Technical Service Bulletin (TSB)

Global Telematics Box Module (TBM) Firmware Over The Air (FOTA) Update From R5N3 R5R1 R5N To 5T1

REFERENCE:	TSB: 08-177-26 GROUP: 08 - Electrical	Date:	April 24, 2026	REVISION:	–
VEHICLES AFFECTED:	2026 (LB) Dodge Charger This bulletin applies to vehicles equipped with Global Telematics Box Module (Sales Code RDG).			MARKET APPLICABILITY: ☒ NA☐ MEA ☐ SA☐ IAP ☐ EE☐ CH NOTE: This bulletin applies to the North America market.	
CUSTOMER SYMPTOM:	Customers must experience a Malfunction Indicator Lamp (MIL) illumination and the vehicle must exhibit/set one or more of the following Diagnostic Trouble Codes (DTCs): • B1560-11 - Cellular Antenna 1-Circuit Short To Ground. • B1560-13 - Cellular Antenna 1-Circuit Open. • B1561-11 - Cellular Antenna 2 Short To Ground. • B1561-13 - Cellular Antenna 2-Circuit Open. • B1562-14 - GPS Antenna-Circuit Short To Ground Or Open. • B22A9-96 - ECU Internal Performance - Component Internal Failure. Customers may also experience the following: • "Uconnect Box Requires Service" Message on the display screen.

Fig. 1

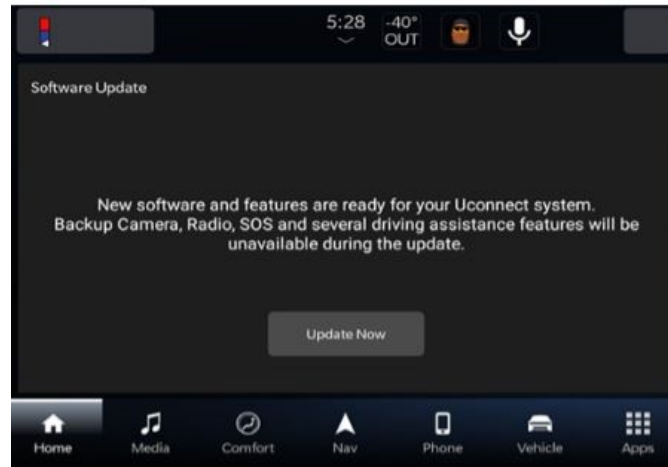
1. The vehicle needs to be in 'Park'. The ignition needs to be in the off position.
2. If the customer selects "Update Now" [Fig.1](#) they can shut off the vehicle and leave. The update will be completed automatically.

Fig. 2

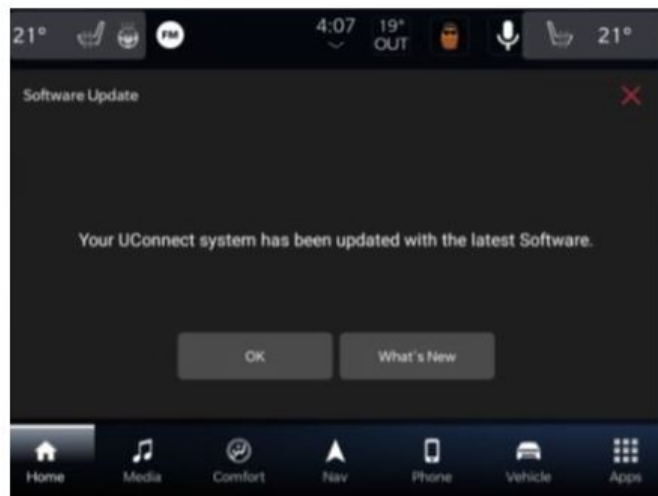
3. Upon completion of update, the radio will display a confirmation message [Fig. 2](#).
